Product Change Notification

Change Notification #: 113753 - 00
Change Title: Intel® Server Chassis P4304XXSFEN
PCN 113753-00
Product Design, Label
Update the Hard Disk Drive Tray to add 2 latches and labels and Update the Safety label with an EAC logo instead of a GOST logo
Date of Publication: March 31, 2015

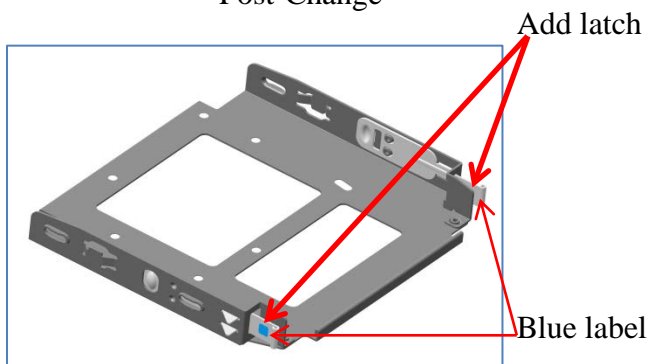
1. Add two latches and labels for the fixed HDD (Hard Disk Drive) tray to enhance the robustness of the HDD tray and indicate the touch point for the HDD tray assembly.

Pre-Change

Post-Change
